**LICENSING TOPICAL REPORT  
SUPPLEMENT**

**Migration to TRACG04/PANAC11 from TRACG02/PANAC10  
for  
Reactor Stability Detect and Suppress Solutions  
Licensing Basis Methodology for Reload Applications**

SUBJECT: FINAL SAFETY EVALUATION FOR GENERAL ELECTRIC HITACHI NUCLEAR ENERGY AMERICAS, LLC TOPICAL REPORT NEDO-32465, SUPPLEMENT 1, "MIGRATION TO TRACG04/PANAC11 FROM TRACG02/PANAC10 FOR REACTOR STABILITY DETECT AND SUPPRESS SOLUTIONS LICENSING BASIS METHODOLOGY FOR RELOAD APPLICATIONS" (TAC NO. ME7104)

SAFETY EVALUATION BY THE OFFICE NUCLEAR REACTOR REGULATION

Figure 4. Typical regional DIVOM slope (TRACG04 vs TRACG02)

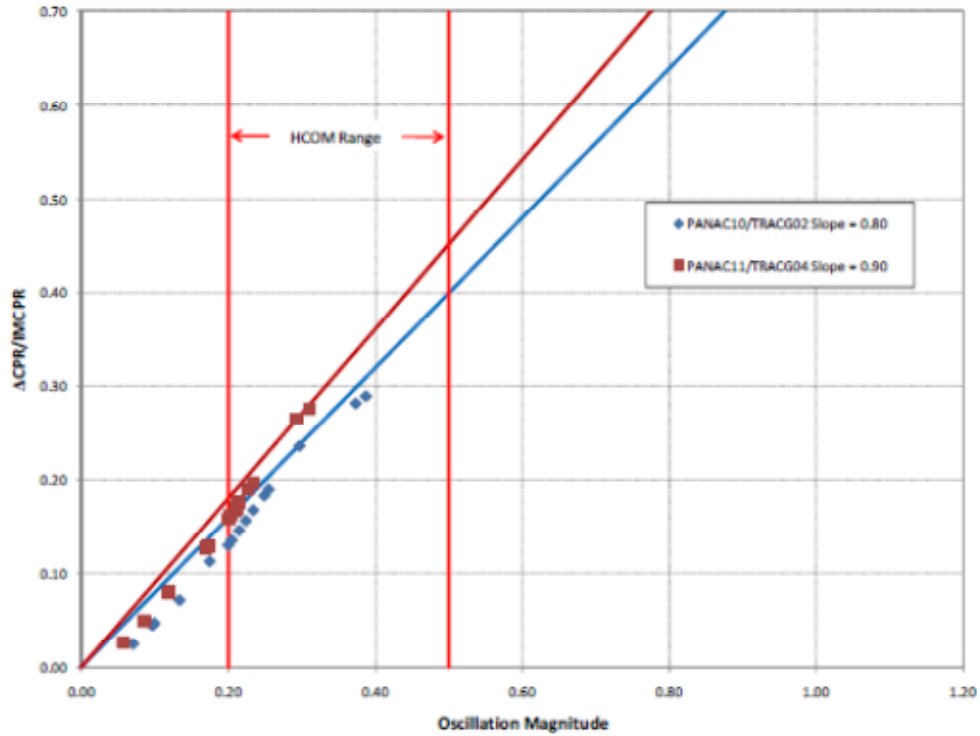
The main results of this benchmark indicate that the DIVOM slopes calculated by both methodologies are essentially identical, with the new TRACG04/P11 methodology being slightly more conservative (larger DIVOM slope) than TRACG02/P10. These benchmarks are reproduced here as **Figure 4** and 5. The NRC staff notes that in these figures the red line (TRACG04/P11) is slightly higher than the blue line (TRACG02/P10), which results in lower values of the scram setpoint and is more conservative.

Figure 5-4 Core-Wide Analysis – DIVOM Results

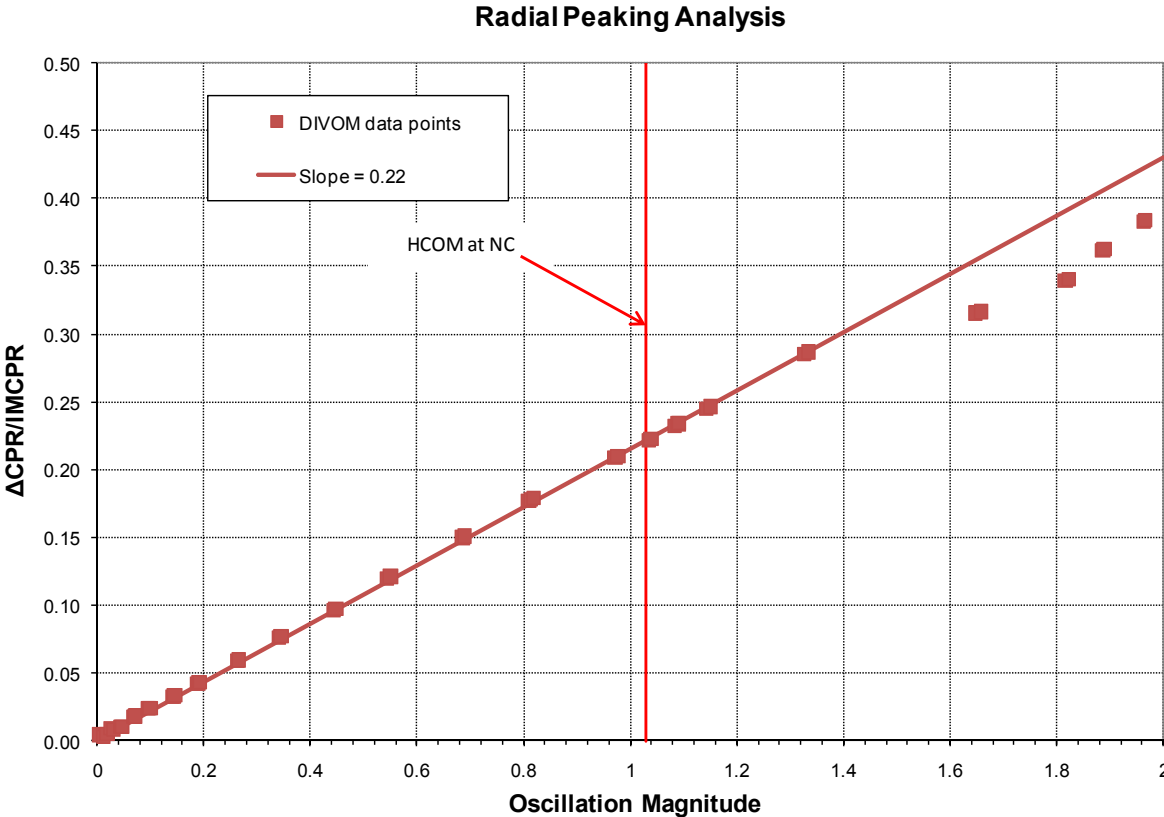
*Section 4.2 of NEDO-32465, Supplement 1 states that HCOM values at natural circulation are typically between 0.8 and 1.0. In Figure 5-4, a single HCOM value of approximately 1.05 is marked in the figure. How can a bounding DIVOM slope be defined with only one HCOM value instead of a range? Please explain the example of Figure 5-4.*

Section 4.2 of NEDO-32465, Supplement 1 states that HCOM values at natural circulation are typically between 0.8 and 1.0. In Figure 5-4, a single HCOM value of approximately 1.05 is marked in the figure. How can a bounding DIVOM slope be defined with only one HCOM value instead of a range? Please explain the example of Figure 5-4.

In the RAI question response, GEH clarifies that for normal Solution III applications, a HCOM range would be used. However, for Solution ID applications, a single HCOM value specified by the methodology is used. In the particular case of Figure 5-4 of the TR, the purpose of that
